PLANNING COMMISSION AGENDA REPORT

SUBJECT: PLANNING APPLICATION PA-07-53
257 16TH PLACE

The applicant is proposing to construct a 3-unit, 2-story residential common interest development with variances from driveway parkway landscaping, private open space requirements, a minor modification for reduced driveway width, and a minor design review for second-to-first floor ratios and average second floor left side setbacks.

SITE PLAN

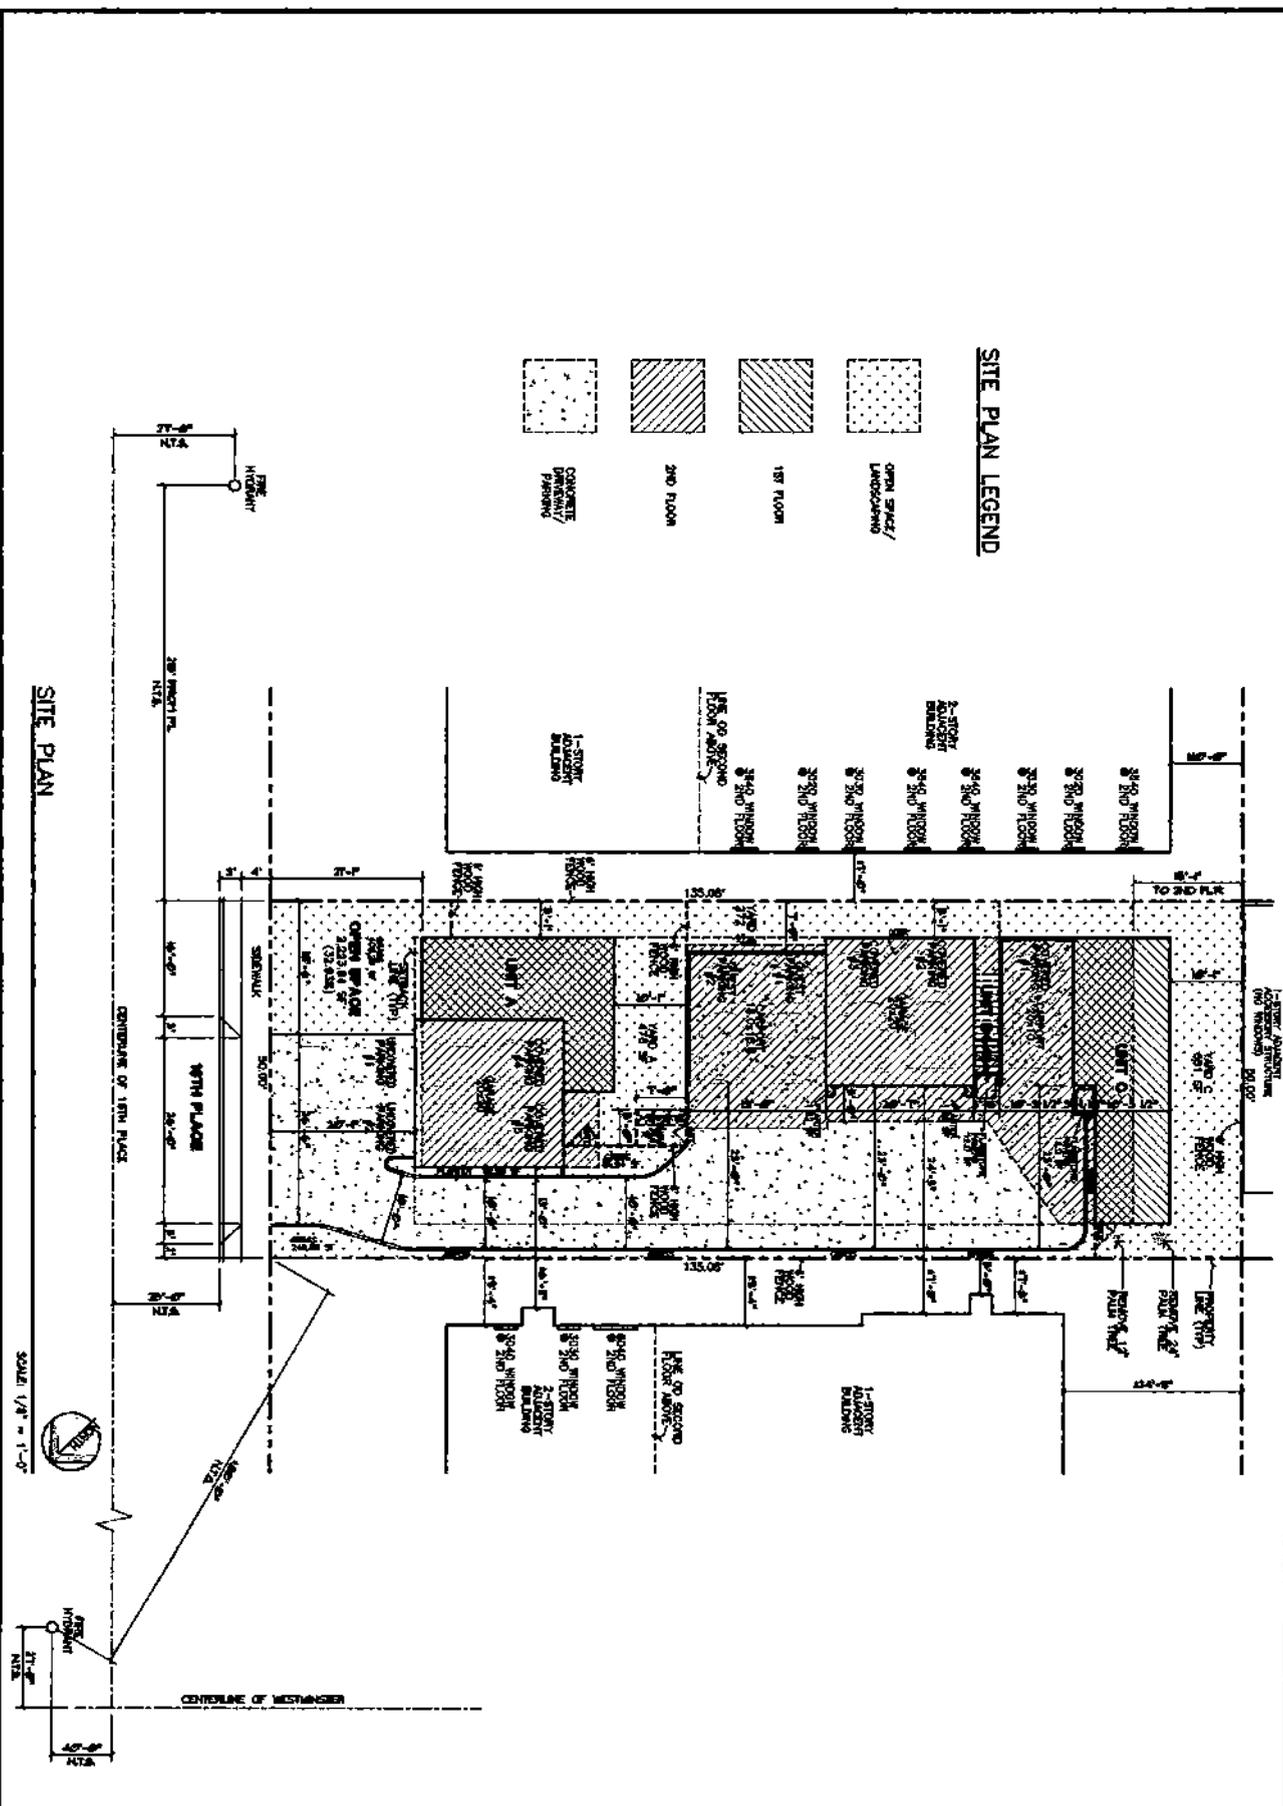
The applicant requests approval of a variance from the 40% overall open space requirement (33% proposed) to accommodate the project.

It is staff's opinion that application of the open space requirement will not deprive the property of privileges enjoyed by others in the vicinity under the same zoning district because the nonconforming lot width and area do not preclude a project from providing adequate open space, especially when the existing buildings will be removed and the project is an entirely new development. There have been many projects on nonconforming lots that were designed to meet the open space requirement. Additionally, the minimum lot area necessary to accommodate a 3-unit project is 6,534 square feet based on the 1 unit per 2,178 square feet density allowance; the subject lot is 6,754 square feet. Therefore, staff cannot support the open space variance.

The Zoning Code requires that each unit provide an adjoining patio with no dimension less than 10 feet (5 to 7 feet proposed for Unit B).

Unit B (located on the second story) will have exclusive use of an approximately 272 square-foot patio area at grade level, which exceeds the 100 square feet of area that would result in the provision of the minimum dimension required. However, the only access to this yard area is through the rear of the 2-car garage on the grade level. It is staff's opinion that this does not meet the intent of the private open space requirement.

The applicant also requests approval of a variance from driveway parkway landscaping (5 feet minimum on house side and 10 feet combined width required; 1 foot on house side and 2 to 5 feet combined width proposed).

It is staff's opinion that the lot's nonconforming 50-foot width (100 feet required) creates the justification for approval of a variance from driveway parkway landscaping requirement since the nonconforming lot provides limited area to accommodate the required 16-foot driveway, 5-foot side building setback, and a 10-foot combined width for driveway parkway landscaping. However, the intent of the driveway parkway landscaping requirement was to provide visual relief for common driveways serving multiple dwelling units. It is staff's opinion that the 1-foot landscape strips on both sides of the driveway are not sufficient to break up the appearance of the paving visible from the street. Specifically, more than half of the lot's width (26.5 feet) is proposed to be paved within the front setback area.

Although staff feels that special circumstances to the property exist to justify approval of a variance for reduced driveway parkway landscaping, staff is not recommending approval of the proposed design because it does not meet the intent of the driveway parkway landscaping requirement, especially since the open space requirements are not met and typically more landscaping in the front setback area is proposed for a new development.

The applicant requests approval of a minor modification for reduced driveway width (16 feet required; 10 feet proposed).

Typically, staff has no objections to allowing a reduction in the driveway width requirement for a lot with a nonconforming width because it allows for some landscaping on both sides of the driveway. However, the reduced driveway width still results in inadequate open space and driveway parkway landscaping. Therefore, it is staff's opinion that a reduced driveway does not enhance the project in this case, especially when the cumulative effects of all the requested deviations for this single project are considered.

SECOND FLOOR PLAN

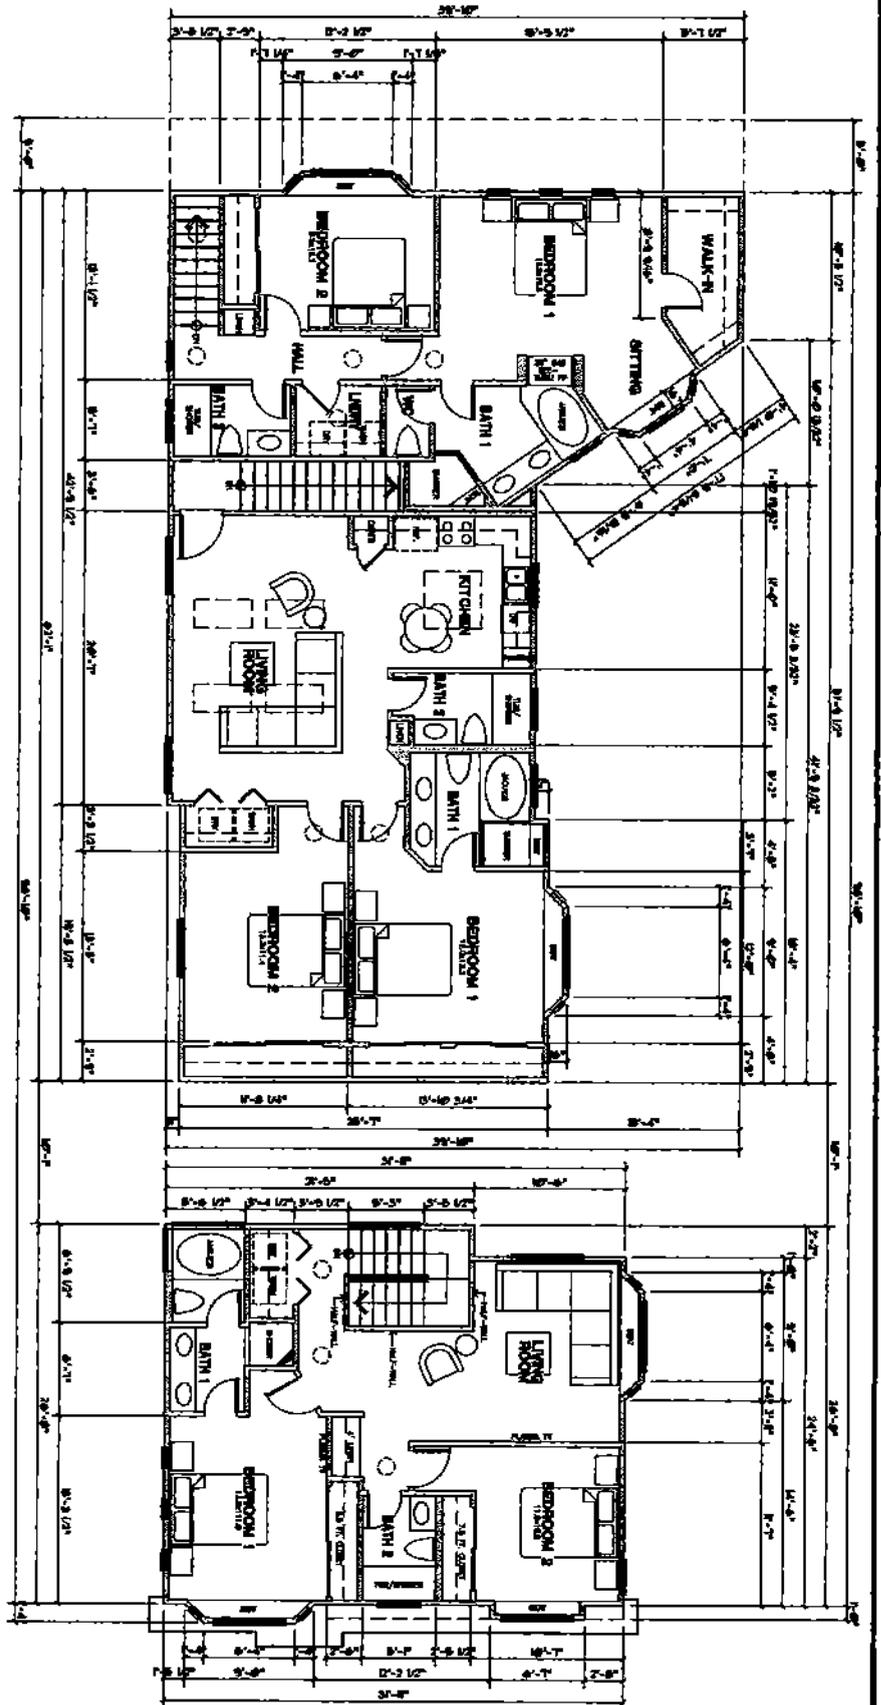
To minimize second story mass, the City's residential design guidelines recommend that the second floor not exceed 80% of the first floor area and the second story be set back an average of 10 feet from the side property lines. The proposed second floors are 100% and 114% of the first floors, and 5-foot left side setbacks. Staff is not opposed to the second-to-first floor ratios since their size and scale are compatible with other 2-story structures in the area. However, it is staff's opinion that although a 1-foot offset, siding and belly band are incorporated in the revised plans, the left side of both structures still lack variation in building planes and roof forms. The 5-foot second floor left side setback along majority of the length of the buildings create a boxy appearance which is inconsistent with the intent of the design guidelines. Additionally, staff is concerned about Unit B's "bedroom 2" and "living room" windows having direct views into windows on the adjacent 2-story building to the east at 5- to 6-foot setback from the property line.

EXTERIOR ELEVATIONS

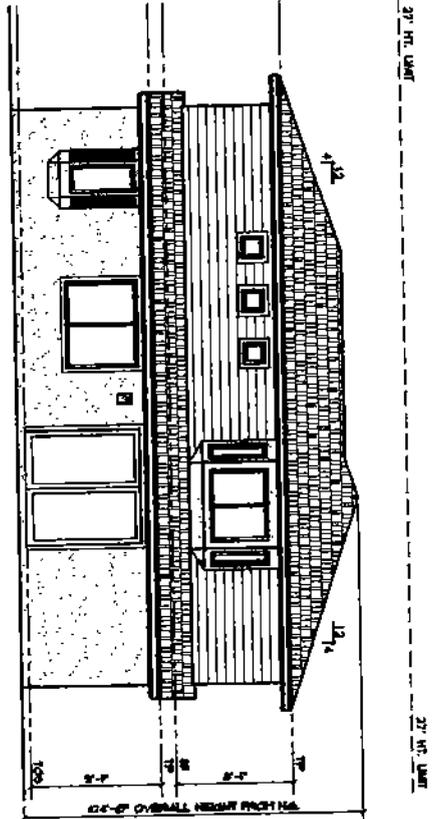
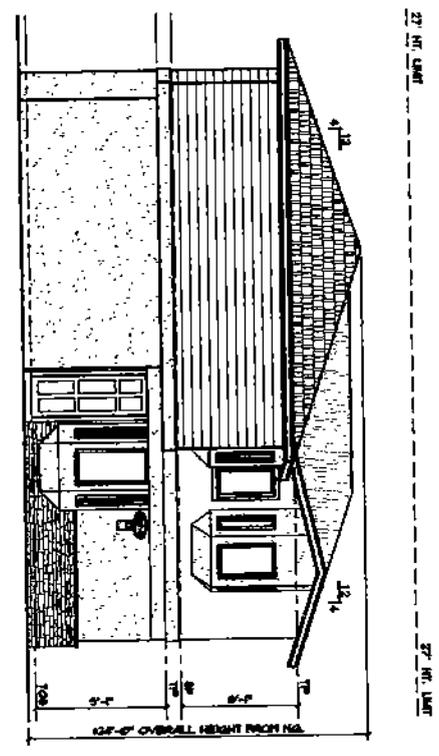
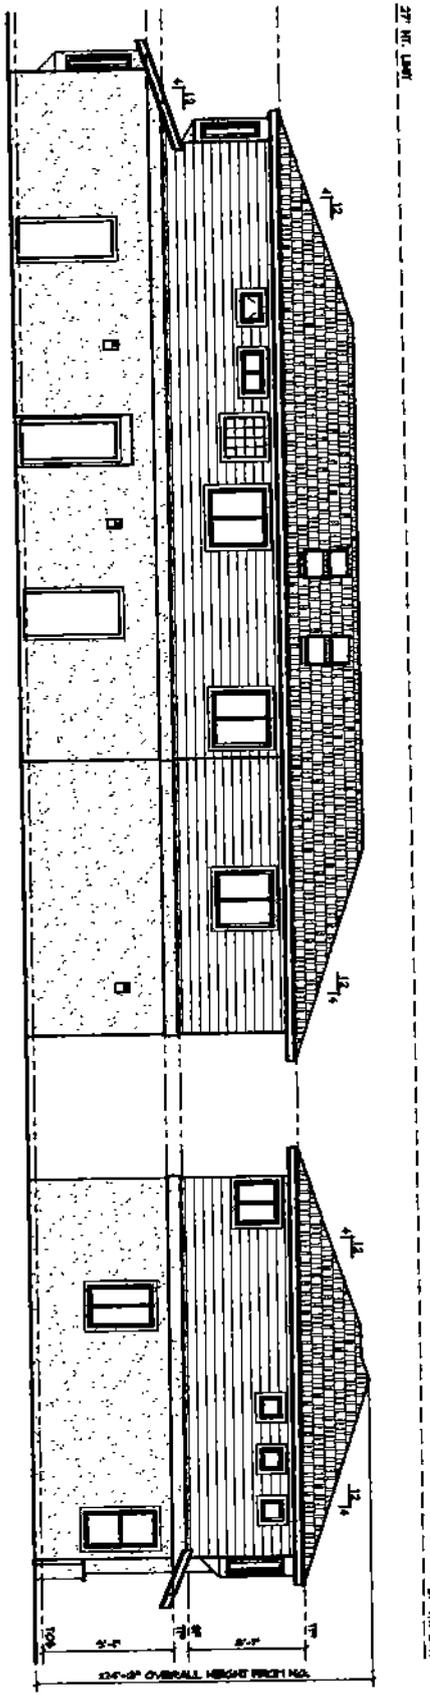
The exterior elevations of the proposed structures will consist of stucco, stone veneer, fiber-cement siding, stucco trim around windows and doors, and composition shingle roofing. The structures will be 24 feet high (maximum 27 feet allowed).

- A. The information presented does not comply with Costa Mesa Municipal Code Section 13-29(14)(a) in that although the scale of the buildings are compatible with structures in the area, the 5-foot second floor left side setbacks along the majority of the length of both buildings create a boxy appearance which is inconsistent with the intent of the design guidelines. Additionally, Unit B "bedroom 2" and "living room" windows will also have potential privacy impacts on the adjacent 2-story building to the east.
